## Response to Request for Additional Information – Westlink Industry Park – Stage 1 Modification 6 – Warehouse 3 Customer Design Changes (SSD-9138102-Mod-6)

## Table 1 Response to Government Agency Comments

Figure 1 Pedestrian Access Plan

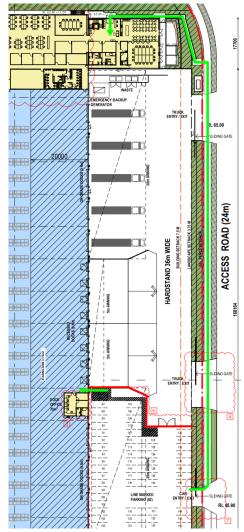
The large office component will be situated approximately 125m north of the car park for the site. Considering the number of employees there is concern for conflicts between truck accessing the site and the employees that will need to walk to enter the office. Please re-consider the location of the car park to be closer to the main office component or alternatively provide internal pedestrian paths to ensure the visibility to minimise the potential for conflicts.

The subject car parking has been purposefully positioned on the southern portion of the hardstand area by the Applicant and future tenant to not impact on the efficiency of warehouse operation. Warehouse 3 is a splayed warehouse with the southern portion comprising a reduced depth. Therefore, the positioning of the overflow car parking on the northern portion would create longer distances between on-grade loading docks and racking, increasing internal freight loading/unloading times.

The proposed 62 car parking spaces on the hardstand represent overflow spaces from the primary car park located on Lower Ground Floor which includes 84 spaces (incl. 2 accessible spaces). The primary car park will be utilised by office workers, who would only utilise the overflow car park once the primary car park is at capacity (peak periods), with the overflow car park to be primarily used by warehouse workers.

This arrangement ensures pedestrian access is optimised and travel distance is minimised for each worker group. As illustrated in **Figure 1**, warehouse workers would utilise pedestrian access adjacent to the dock office directly from the overflow car park. In the event office workers occupy the overflow car park, suitable access is available via the pedestrian pathway along the Access Road.
